PLANNING, ZONING, & BUILDING DEPARTMENT
PZ&B Staff Memorandum: Town Council

FROM: Wayne Bergman, MCP, LEED-AP Director PZ&B 
SUBJECT: ZON-24-058 (ARC-24-073) 400 ROYAL PALM WAY (COMBO)
MEETING: JULY 10, 2024 TOWN COUNCIL

REVISED MEMO 07/09/24

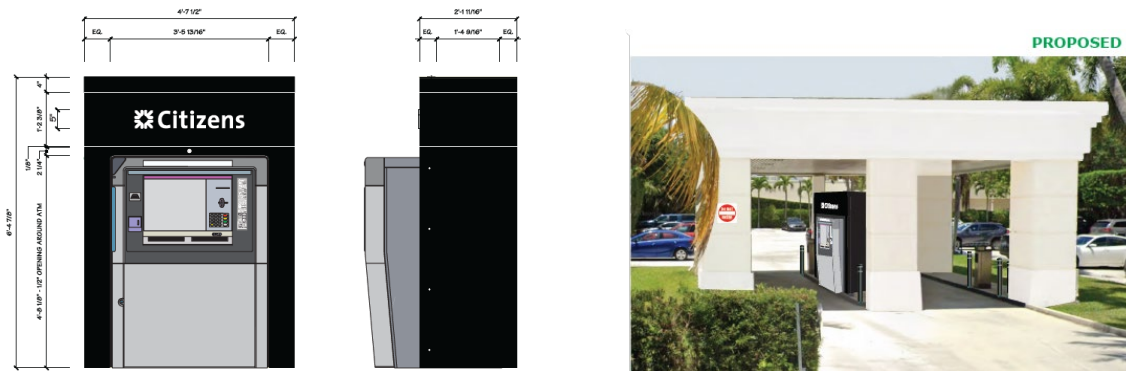
As it pertains to **Variance #1**, a variance is being requested to permit signage on an ATM surround shroud where signs are not permitted. The applicant is requesting a small brand name upon the vehicle-facing side of the device, "internal" to the site, not directly facing the roadway.

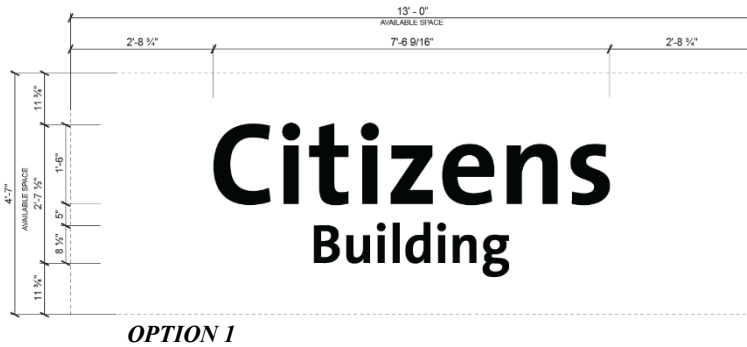
The applicant has proposed 2 options for the north façade. Option 1 is a 19.81 SF sign, 28' above grade, without a company logo in which the word "building" has been added. Building Identification Signage (i.e., Text which includes the word "building" and does not contain company logos) does not have a maximum height above grade and is not counted towards existing sign area.

If this sign was approved, no variances would be required for proposed signage on the north elevation. However, the applicant has provided option 2 which pertains to variances 2-4.

This plan features a 13.09 square foot sign with company logo. WITH NO CHANGE FROM LAST MONTHS PROPOSAL, this proposal requires a variance for a sign 28' above grade (in lieu of 15' maximum permitted), a variance for a total sign area of 25.25 square feet (in lieu of the 20 sq ft maximum permitted, and a variance for a logo area of 2.25 square feet (in lieu of the 1 square foot maximum permitted, no change from last month). A total of three variances are required to achieve this proposed sign plan. Staff would suggest the option which does not require any variance relief.

West Façade

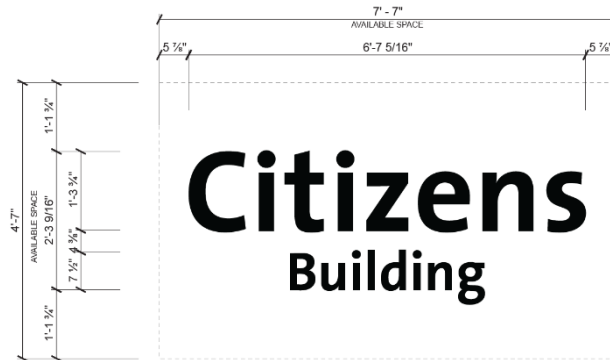
The applicant has also provided 2 sign plan options on the west façade. The first option is a 15.18 square foot sign with the word “building” on it. One variance is required due to the sign fronting a parking lot in lieu of a roadway. This proposal requires 2 less variances than the previous proposal.

As it pertains to variances 5-7, the “West Elevation Alternate” plan features a 9.09 square foot sign with company logo. Variances are required for a sign fronting a parking lot (in lieu of a roadway, no change from previously presented), for a sign 28’ above grade (no changes from previously presented), and for a logo size of 1.29 square feet (in lieu of the 1 square foot maximum permitted, NO CHANGE from the previous proposal). **Staff would not suggest approval of any variances for the west elevation where signs are prohibited all together.** However, should the council find merit in allowing a signage to signify the main entrance of the bank, staff would recommend a modification lowering the sign to the height of a more traditional sign band. Visible to pedestrians navigating to the entrance in the parking lot, not as a means to capture the attention of motorists traveling east bound on Royal Palm Way.

East Façade

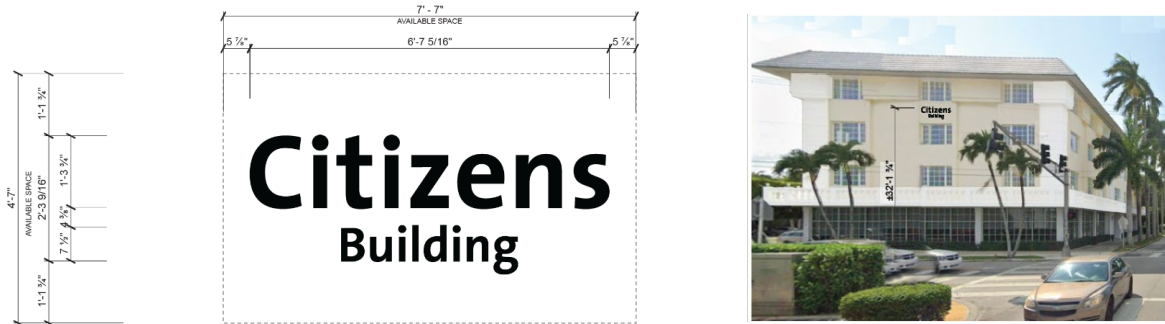
No signage was proposed on the east elevation at last month's meeting, however, a variance was advertised for a sign exceeding 15' above grade. The applicant revised plans after the project was noticed to eliminate signage on this elevation.

The applicant has proposed 2 sign plan options for the east façade of the building. The first option is a 15.18 square foot sign, 28 ft above grade, without a company logo and the word "building" added. Building Identification Signage (i.e., Text which includes the word "building" and does not contain company logos) does not have a maximum height above grade. If this sign was approved, no variances would be required for proposed signage on the east elevation. The applicant previously did not present signage on this elevation to Town Council.

As it pertains to variance 8, the "East Elevation Alternate" plan features a 9.09 square foot sign with company logo. The applicant eliminated signage from this elevation and this signage is newly proposed. Variances are required for a sign 28 feet above grade (in lieu of the 15' permitted). As previously mentioned, the revised plans indicate a new variance that was not advertised and will not be analyzed.
